ADDENDUM NO. 3

CITY OF MASSILLON, OHIO
WWTP UPGRADE 2000

SK-M16-001

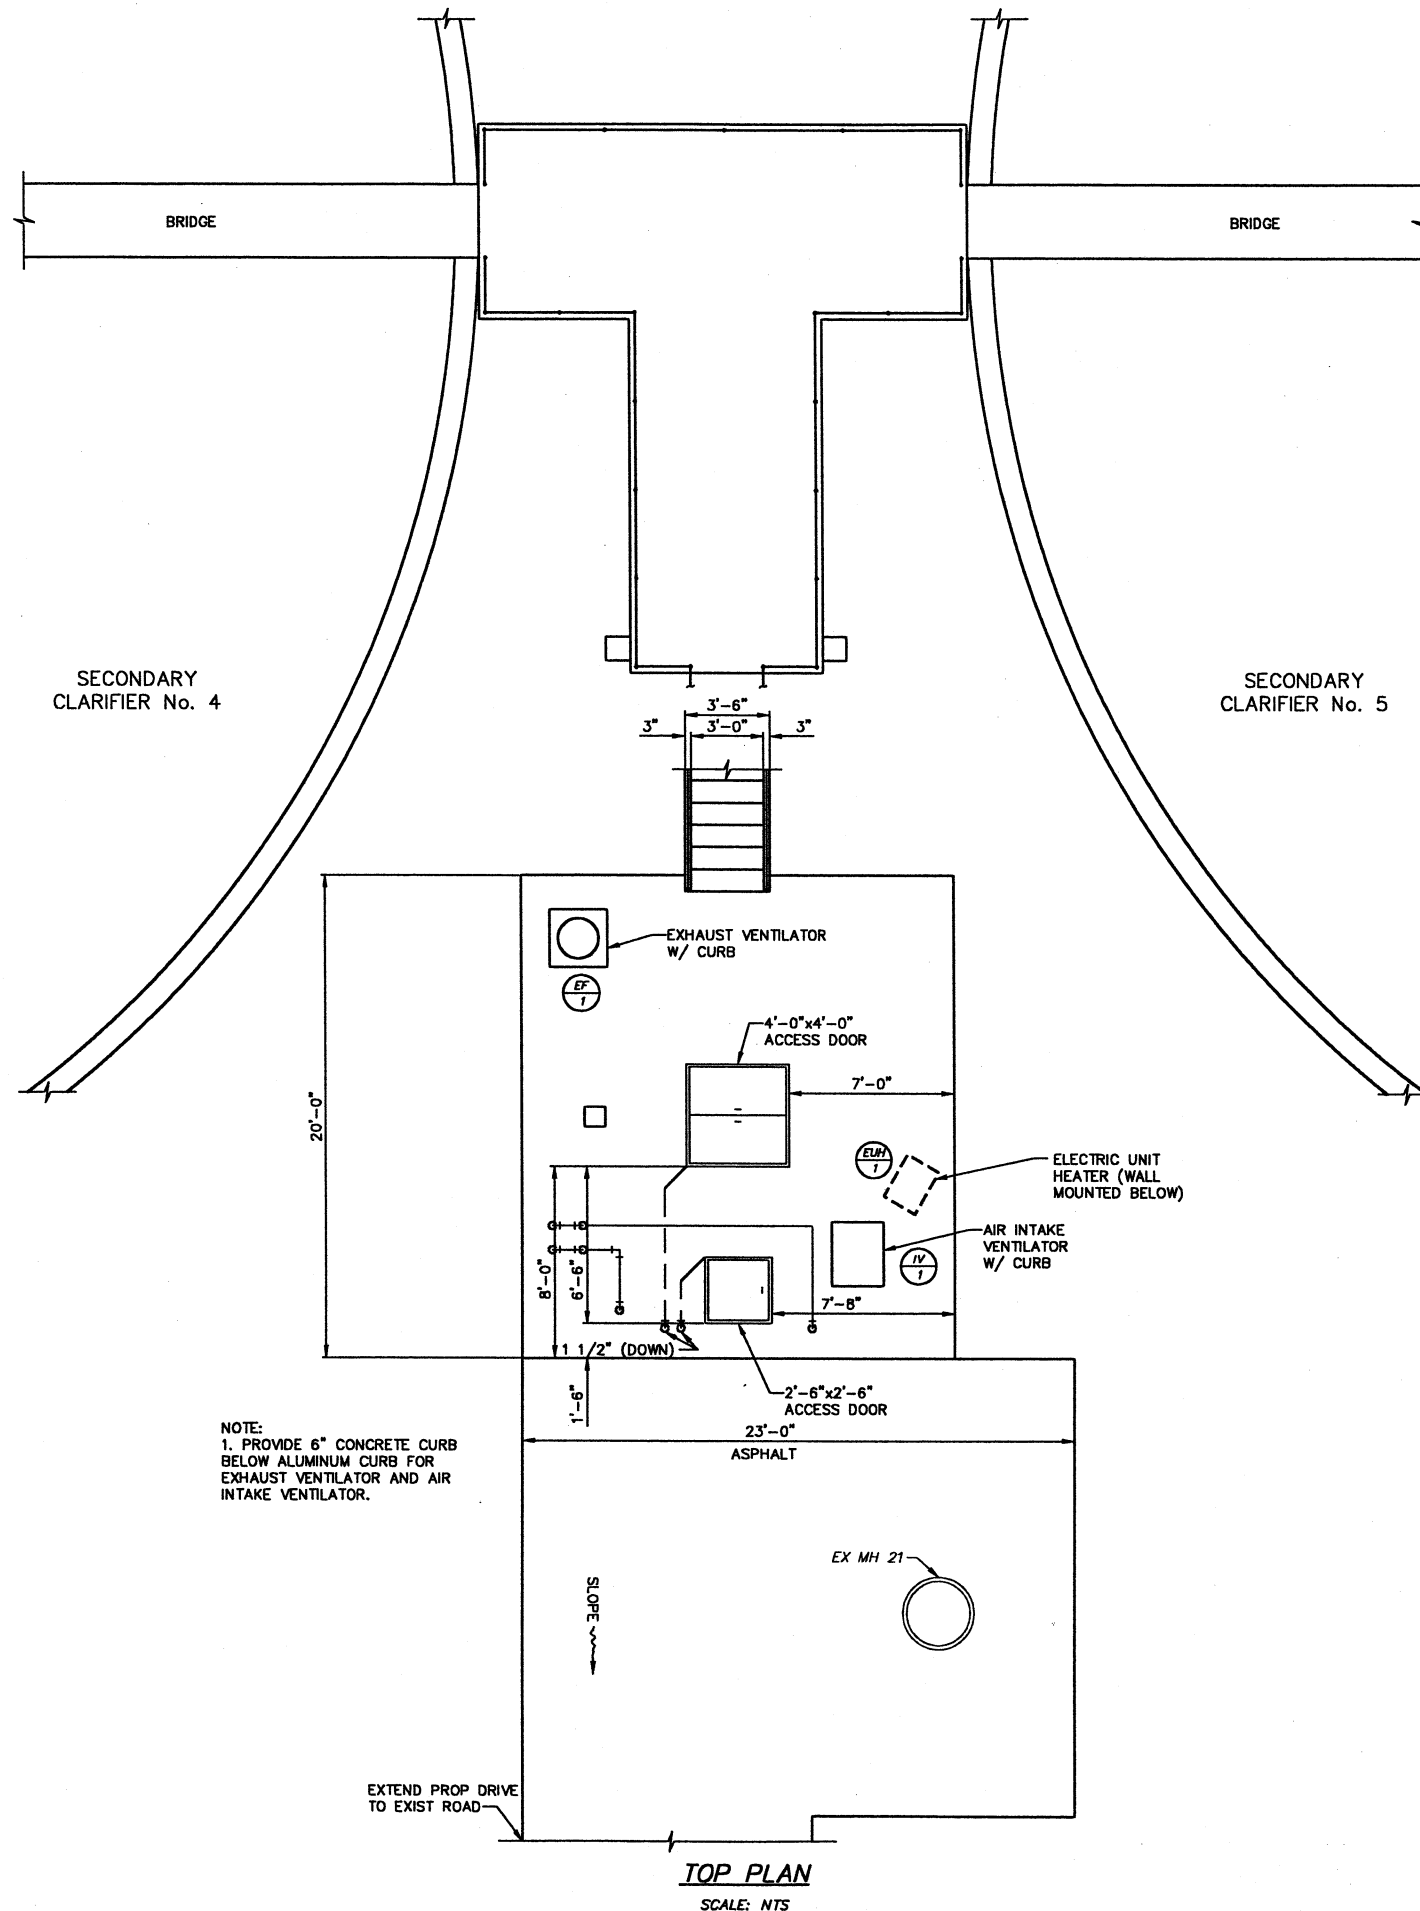
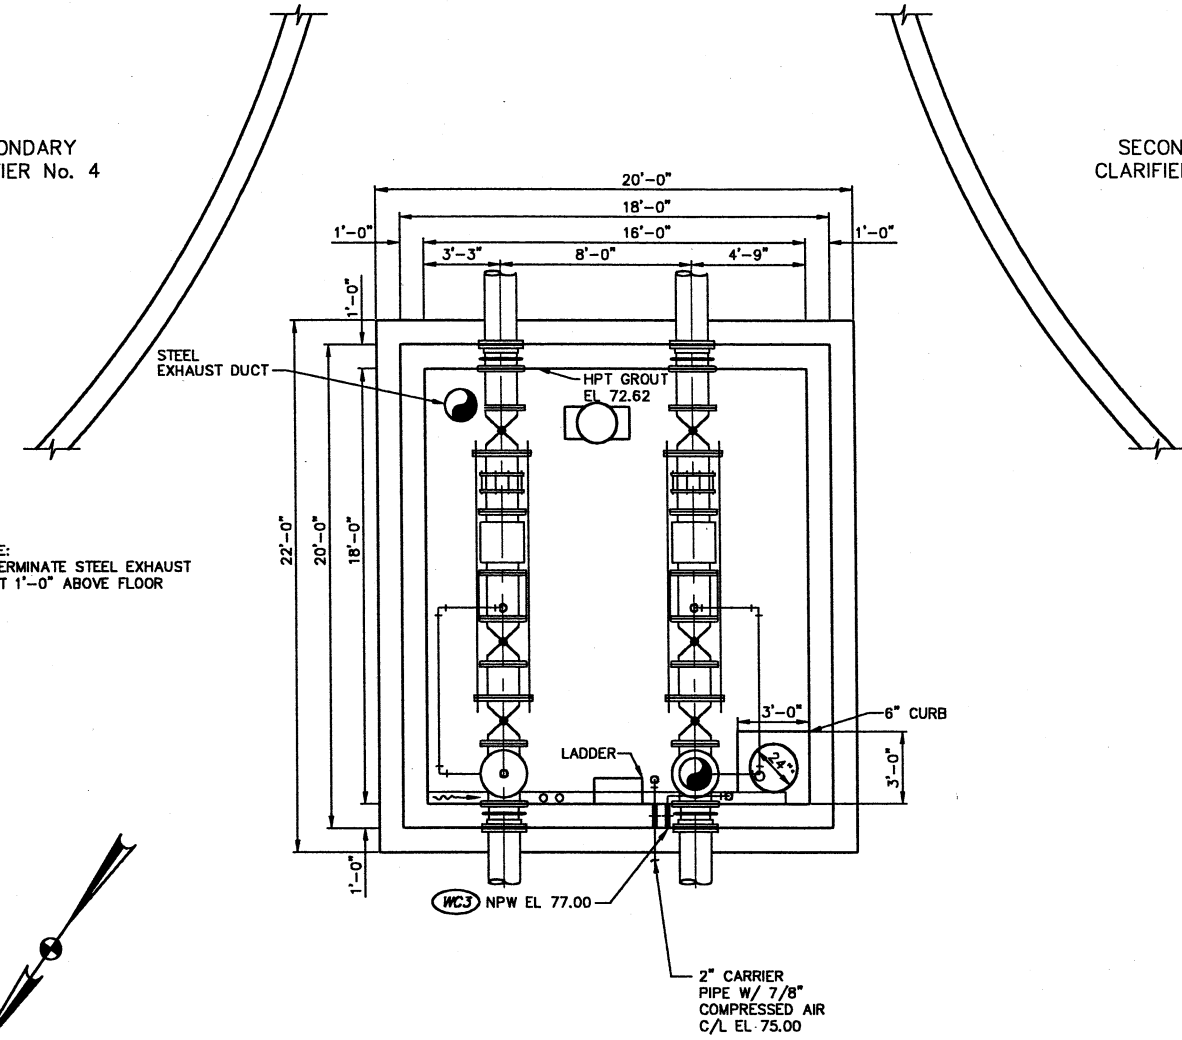
NOTE:
1. TERMINATE STEEL EXHAUST DUCT 1'-0" ABOVE FLOOR

NOTE: 1. MECHANICAL CONTRACTOR SHALL PROVIDE EXHAUST VENTILATOR, AIR INTAKE VENTILATOR, ELECTRIC UNIT HEATER, THERMOSTATS, FREEZESTAT, CONTROLS AND APURTENANCES FOR HVAC EQUIPMENT.
